EXTRACTS FOR DPI-WATER

2. RESPONSES TO ISSUES RAISED ABOUT THE AMENDED PROJECT

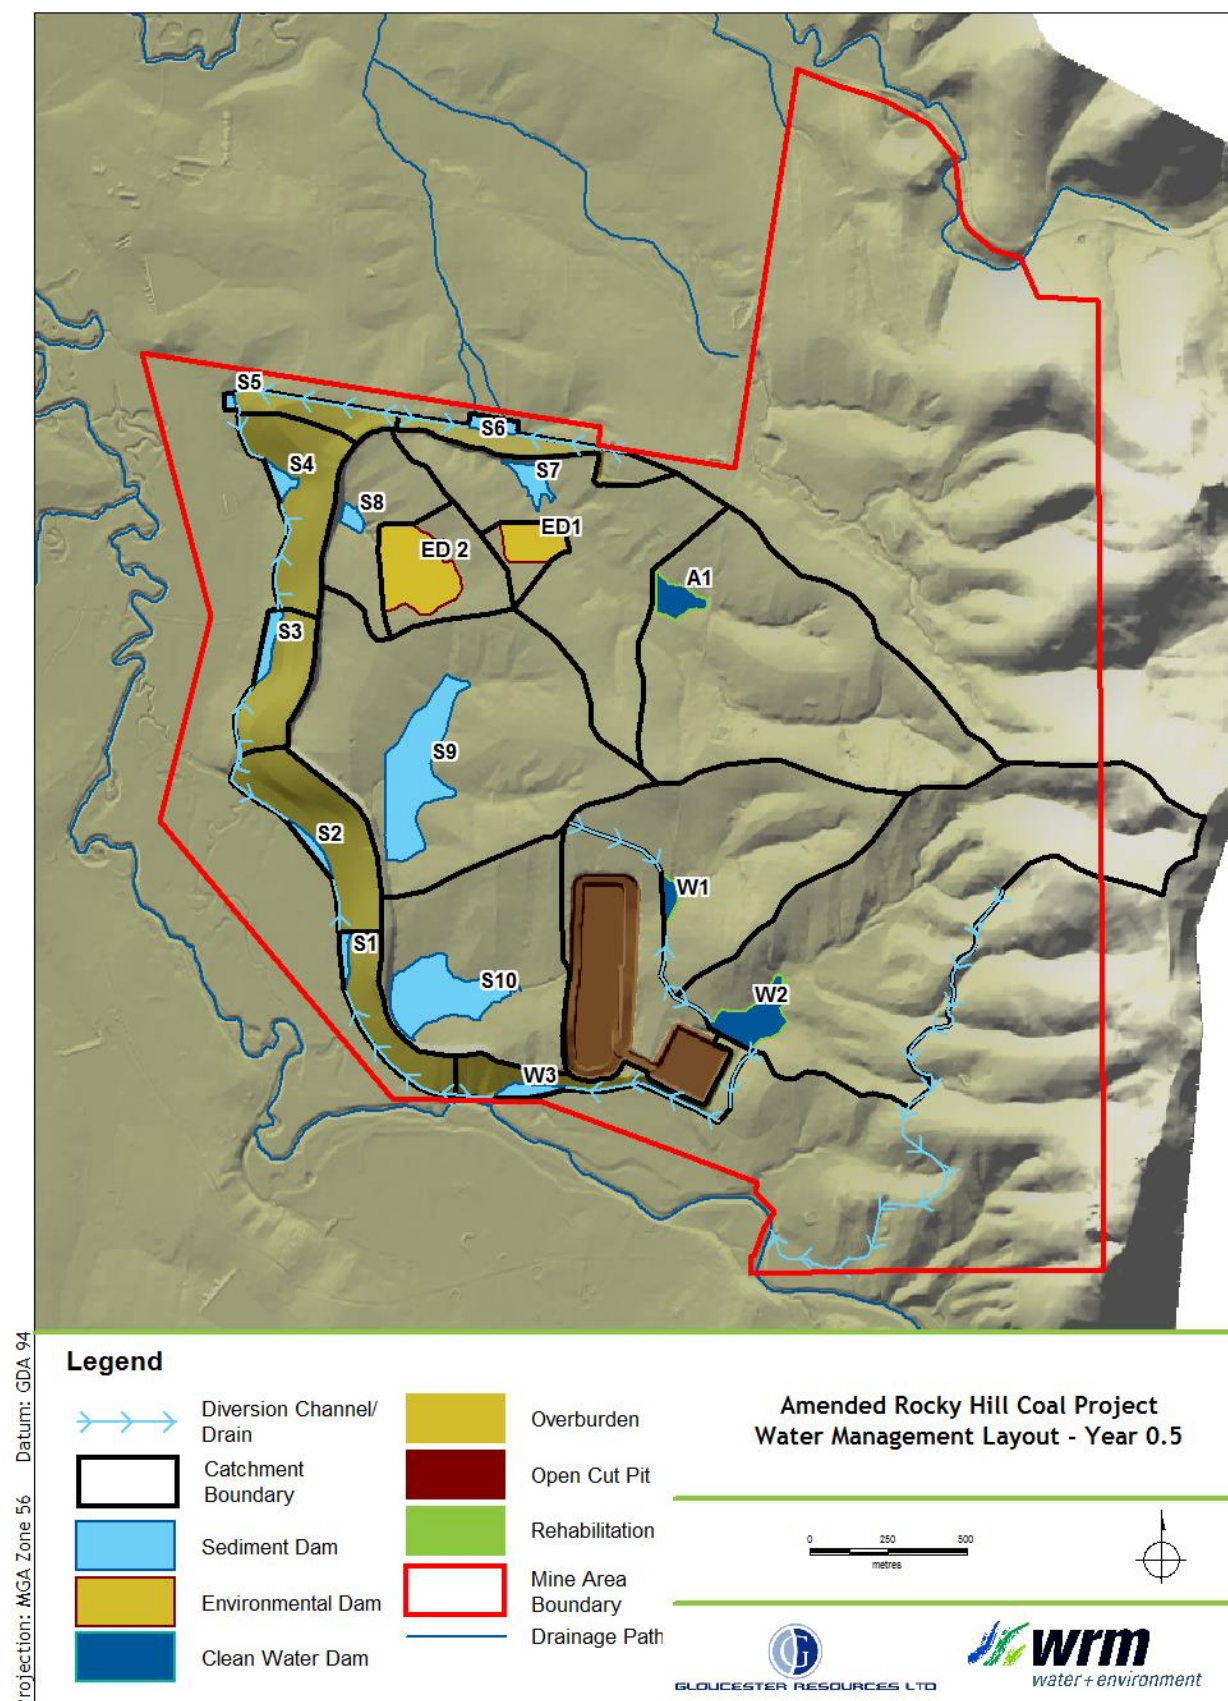
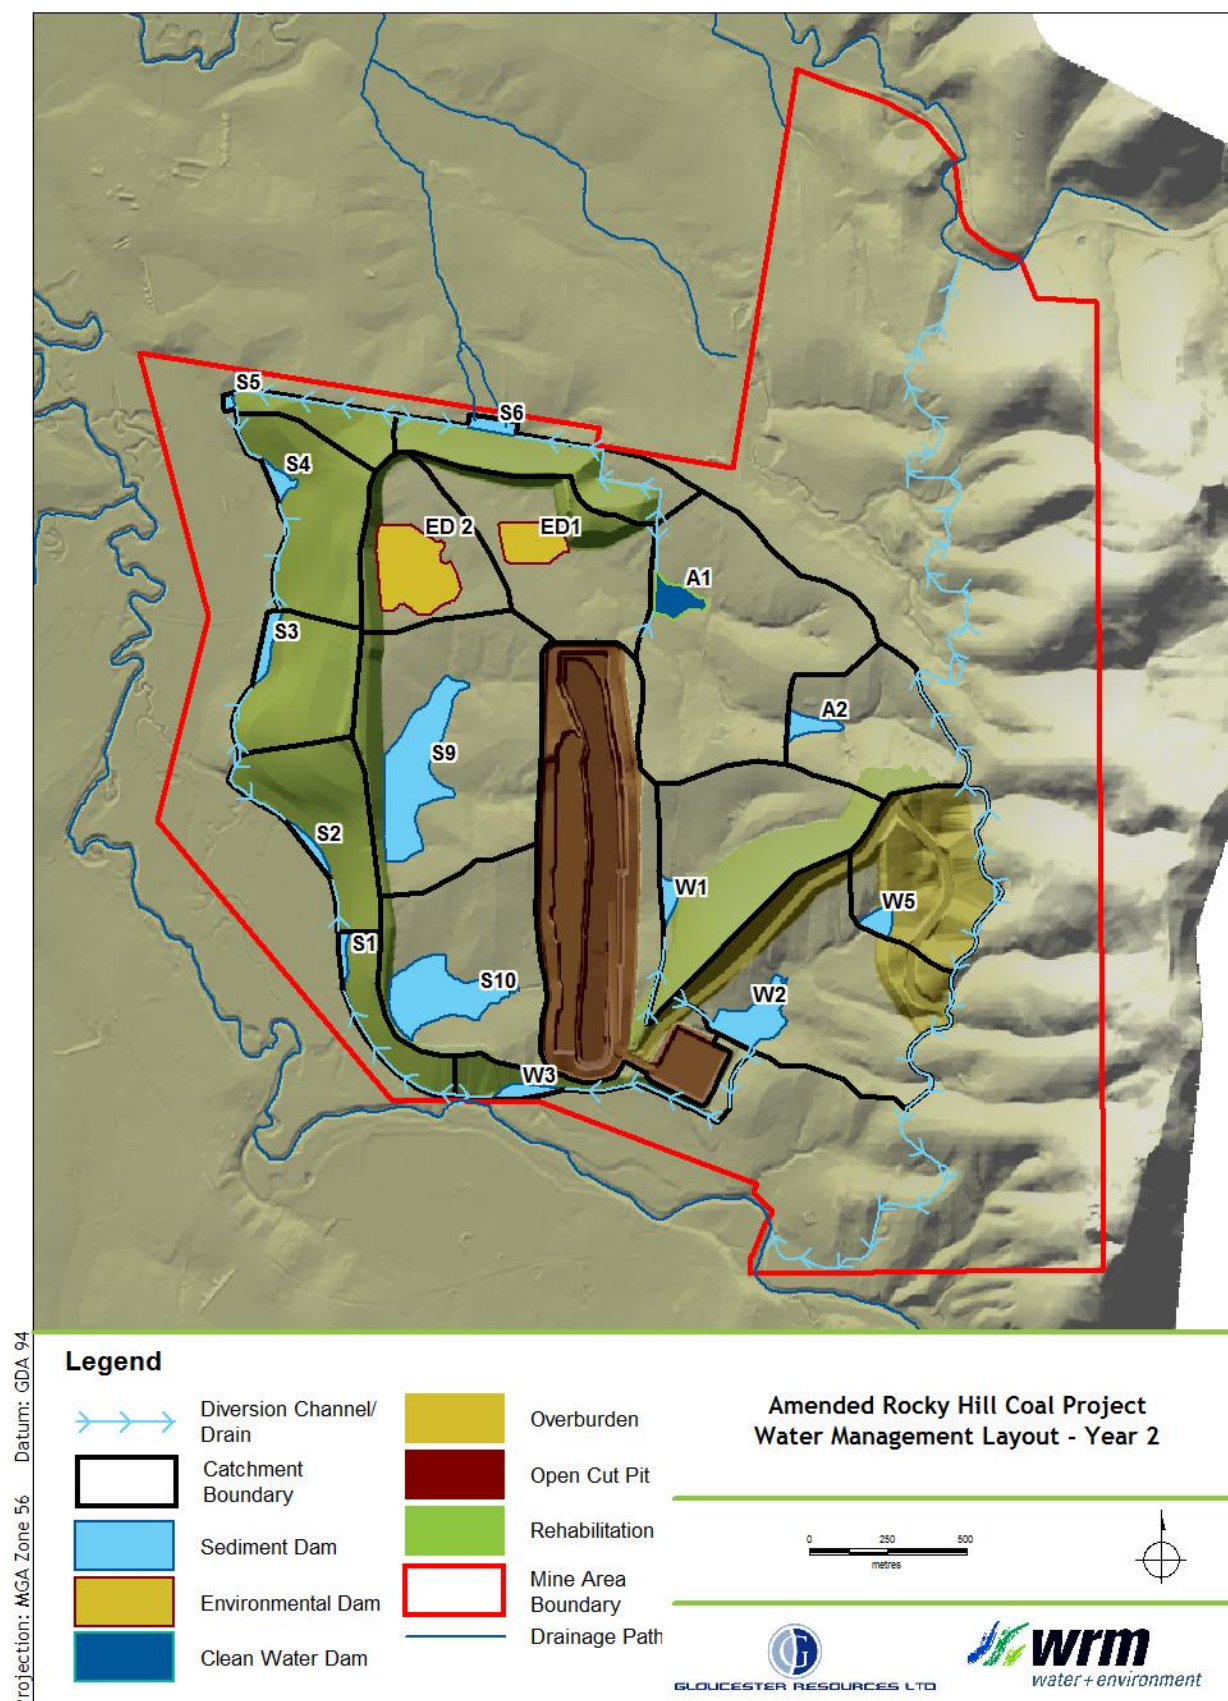
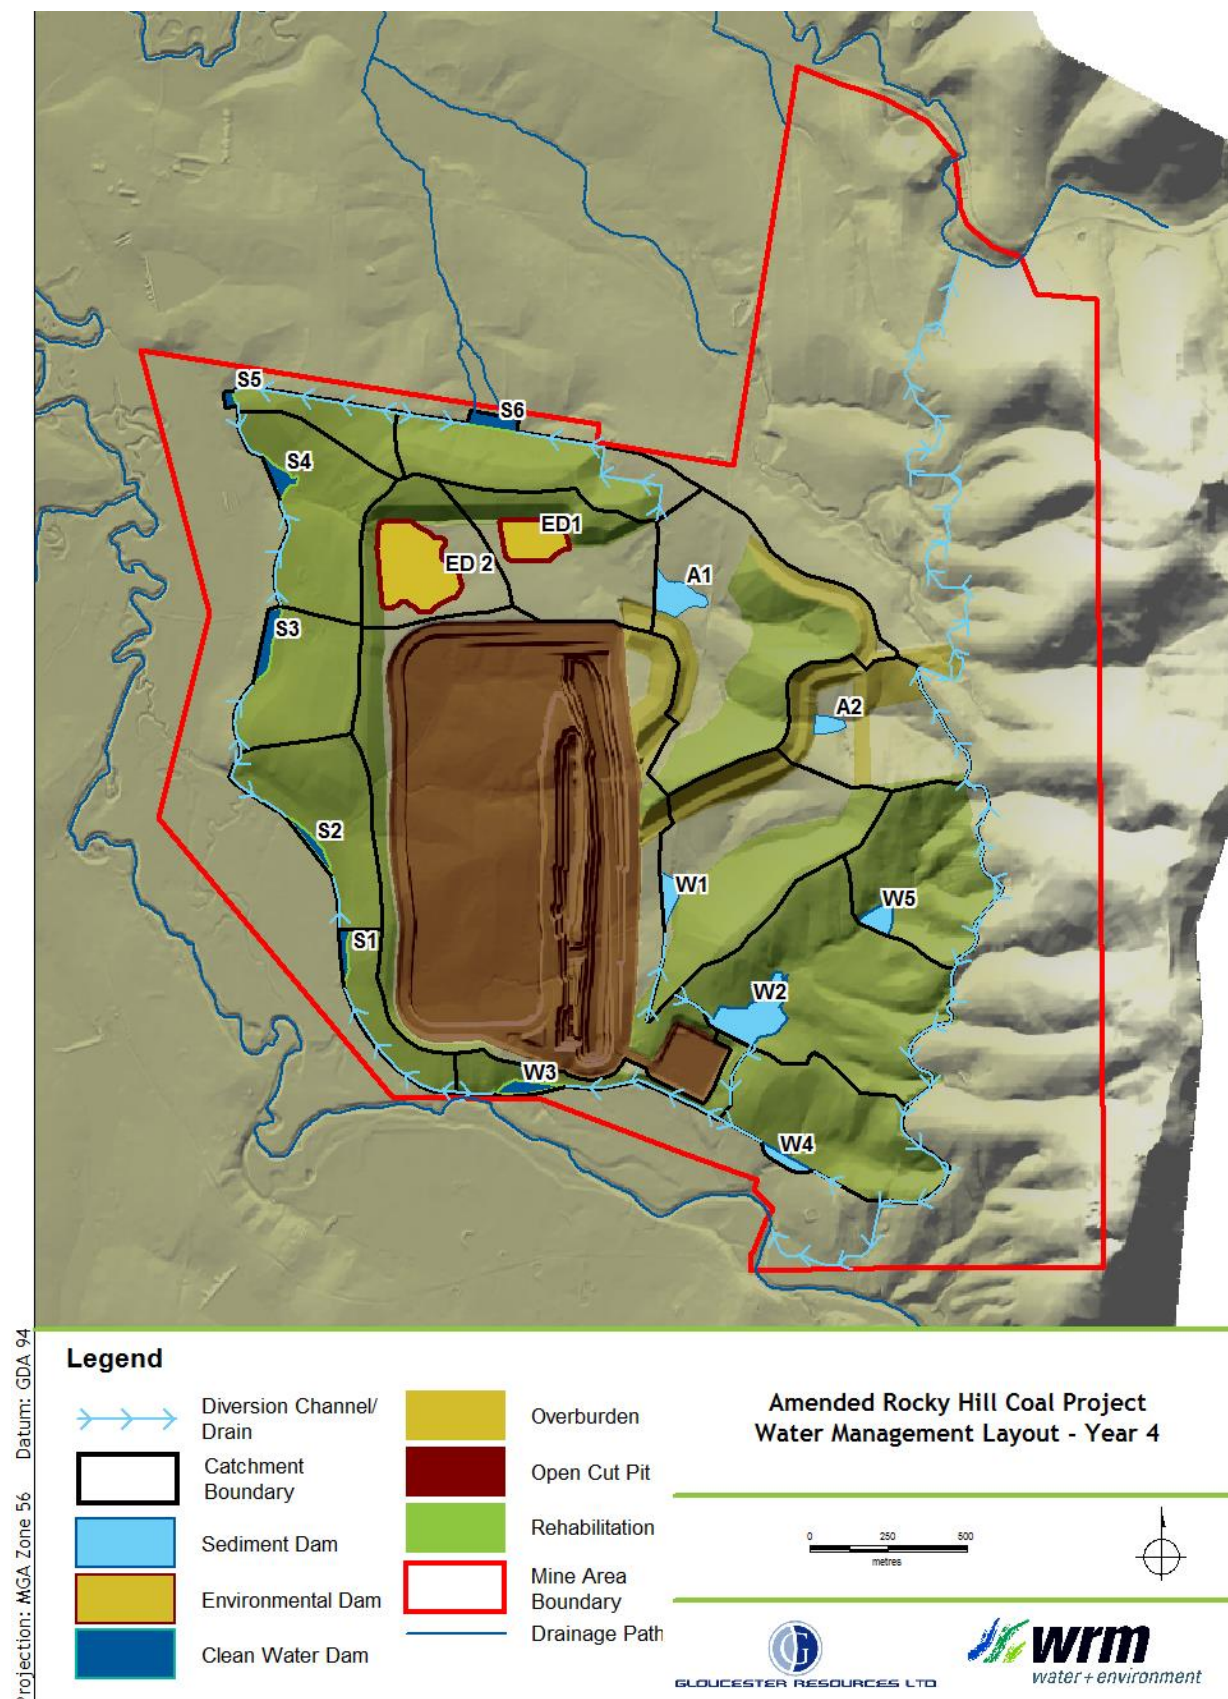
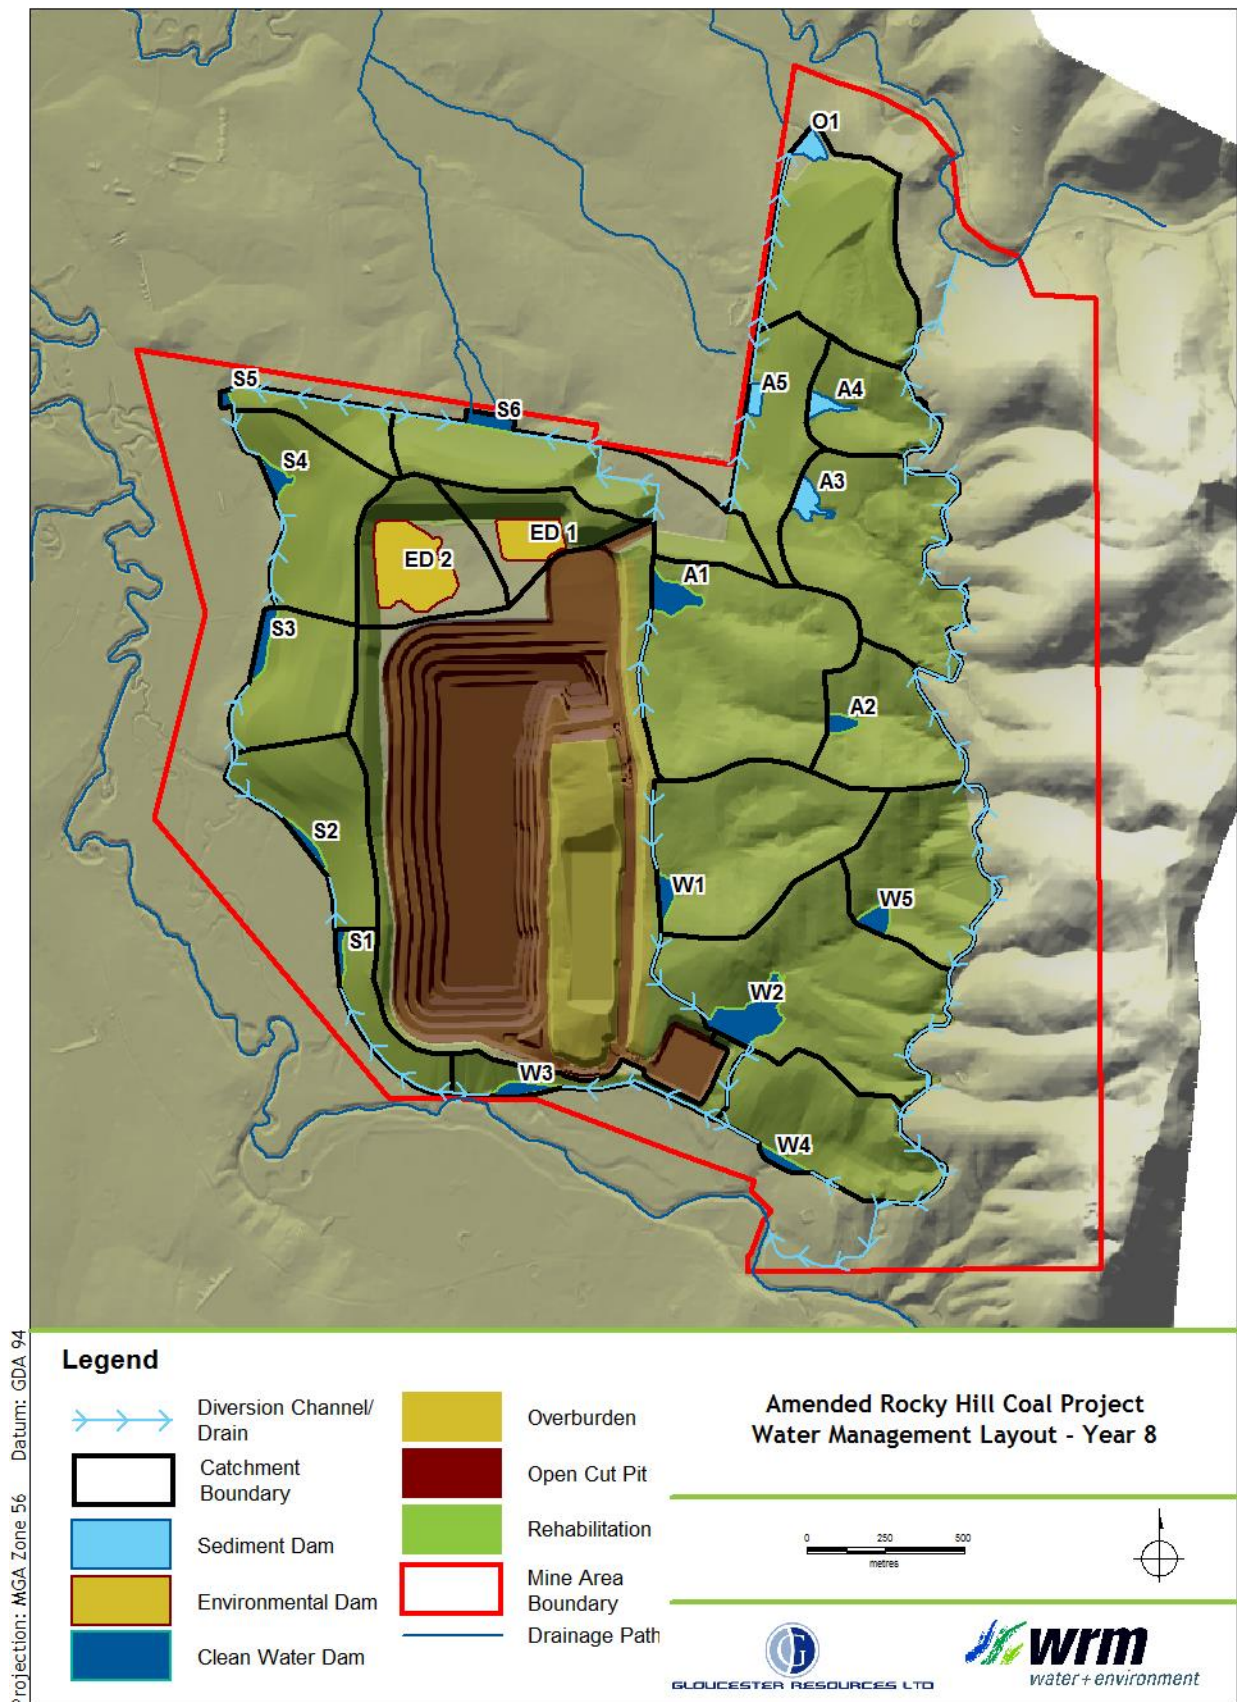
The volume of the proposed clean water dams appears to exceed the proponent's harvestable rights and surface water entitlement. Further information is required on how all proposed dams are to be accounted for, including proposed dams on 3rd order streams that do not fit within exemptions or harvestable rights provisions. This should include a table listing each dam, its strahler order, location, volume, purpose (e.g. clean water, sediment, saline), and the proposed accounting method (e.g. harvestable rights, WAL no., exempt) for different stages of the proposal.

The SWA (Section 1.5.2) gives a maximum harvestable rights dam capacity (MHRDC) for the amended Project of 194ML/yr. **Figure 2.29.10** to **Figure 2.29.15** reproduce Figures 3.2 to 3.7 from the SWA showing the location of all proposed dams. **Table 2.29.4** to **Table 2.29.9** give details of the various dams for each stage of the project including the Strahler classification of the watercourse on which they are proposed to be constructed as well as the proposed accounting method. Only those dams on watercourses with a Strahler classification of 1 and 2 can form part of the harvestable right requirement. It is, however, noted, that whilst three of the proposed dams are located on watercourses with a Strahler Classification of 3, during the life of the amended Project, upstream diversion of water would effectively reduce the Strahler classification of the watercourse on which the dam is located. It is noted that the farm dams constructed on the land to the north of the Mine Area (to receive/store treated water from the treatment plant) would effectively be turkey nest structures without any catchment and consequently would not be subject to any MHRDC requirement.

Water captured in clean water dams¹¹ and used on site would require an entitlement from the Avon River Water Source. The tables show the total volume required if all entitlements for clean water dams were to be offset against the Harvestable Rights held by GRL. From about Year 8, the total clean water dam capacity would exceed the MHRDC (352ML increasing to 436ML compared to the MHRDC of 194ML). GRL would rely upon its WAL entitlements (after offsetting baseflow losses) to account for the shortfall. Between Year 8 and Year 12, the remaining WAL entitlements would not be sufficient to make up for the shortfall (by up to 96ML), and GRL would compare the total clean water dam capacity to the MHRDC of 194ML and its WAL entitlements, and decide whether to decommission or reduce the capacity of the former sediment dams within the Mine Area or to acquire additional WAL entitlements during that period.
